TND ENGINEERING
TRAFFIC, TND, TRANSPORTATION AND CONSULTING

March 29, 2008

Re: Forest Hill Road (FHR)

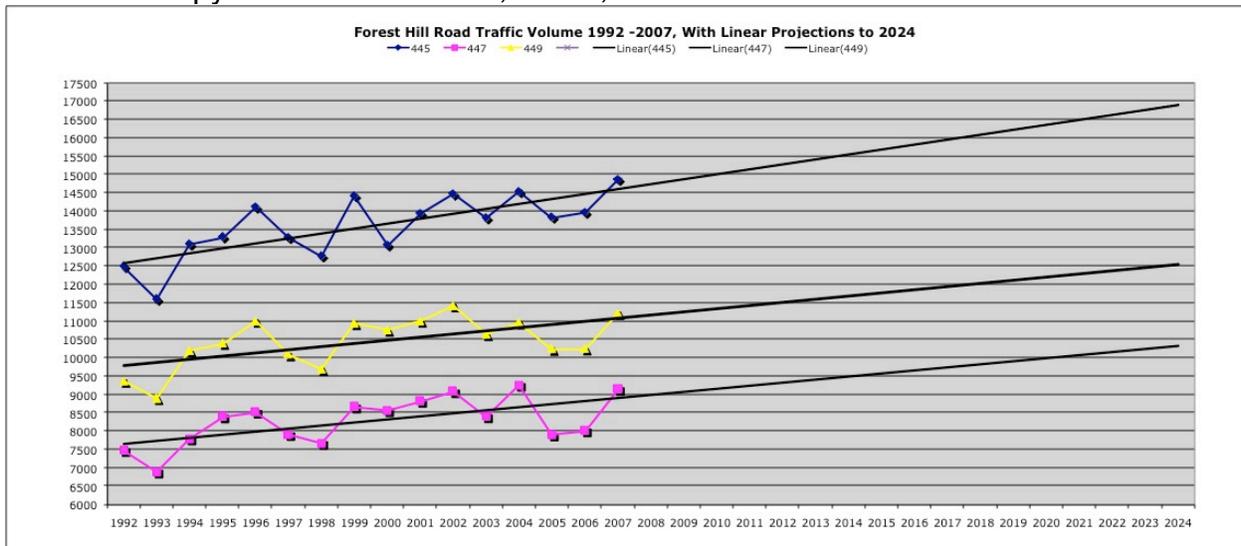
Using the longer time period projects future traffic volume increases of approximately 14% for the highest and lowest volume portions of FHR (these being counters 445 and 447), and 12% for the area around counter 449.

The data shows 2024 projections to be 16,900 for lower FHR with additional future 2024 projections of 12,600 and 10,400 for the other sections. These compare with GaDOT projections of: 22,000 to 25,000; 21,300 and 15,650, respectively.

Stated differently and plainly: if a fair projection of the data from 1992 to 2007 is done, the results show the GaDOT projections to overstate the probable future results by 39% for lower FHR and 55% for upper FHR. These are **huge** differences and plainly show the need to revisit the fundamental assumptions about how FHR should be configured.

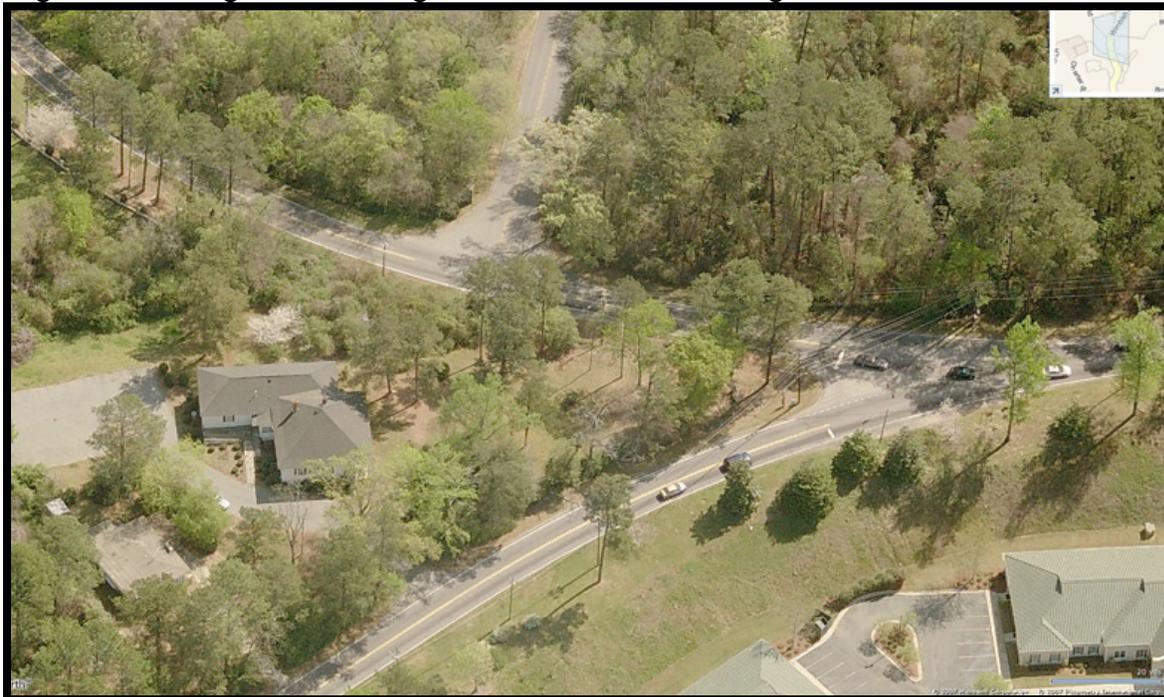
If the primary thoroughfare connection becomes lower FHR to Wimbish, then the heavy left turning movements from Wimbish to FHR would be eliminated- this also eliminates the need for additional “receiving” lanes on lower FHR for those left-turning vehicles.

Realigning FHR with Wimbish & Northminster would also greatly simplify the proposed pair of closely-spaced intersections, and generally simplify operations.

The recent comment that FHR carries about 1,000 more cars a day than Wimbish, thereby tending to make FHR the more dominant alignment is noted, but this design is

not for today and directing more traffic flow to Wimbish seems to make a lot of sense to me. A very rough sketch appears below.

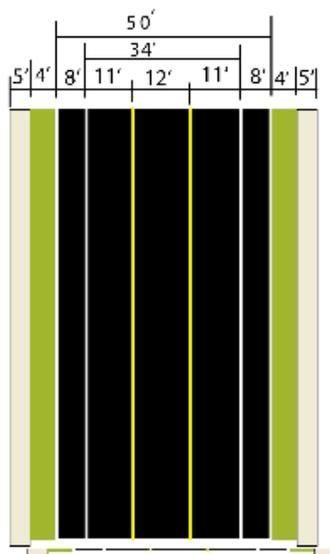
At the Macon Mediation, I proposed, and your group accepted, a proposal for upper FHR that was for two eleven-foot travel lanes with five-foot shoulders with an urban curb (pavement flush to face of curb on both sides of the street); a 32' curb-to-curb proposal (I am going to limit my comments here to the curb-to-curb issue only, as their appears to be agreement beyond the face of curb).

In the first reply, the County's representative(s) offered to reduce their proposed 38' plus 2' gutter pans, or 42' curb-to-curb (hereafter, c-c) dimension to a 36' c-c with the urban curb.

The County's most recent proposal- still in response to the Macon mediation day sketch, **not** the latest offer by your group, is a 32' +2'+2' gutter pan rural section with a 36' c-c. Both of the County's proposals have included a center two-way left turn lane and no shoulders.

Forest Hill Road

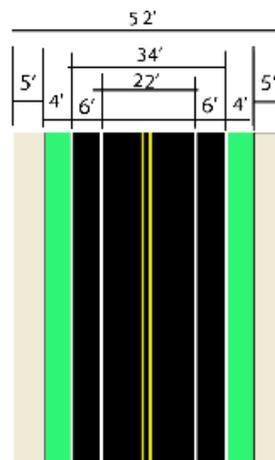
11' lanes beside 6' shoulders will definitely afford a slow deceleration area for right-turning cars, and enough room for cars to pass left-turning cars at slower and more appropriate speeds for a residential neighborhood.

I recognize that this proposal goes "outside" the agreed area by including lower FHR, but for me the **significant** errors in the future traffic volume projections, coupled with the possible realignment of FHR and Wimbish compel the additional diagram.
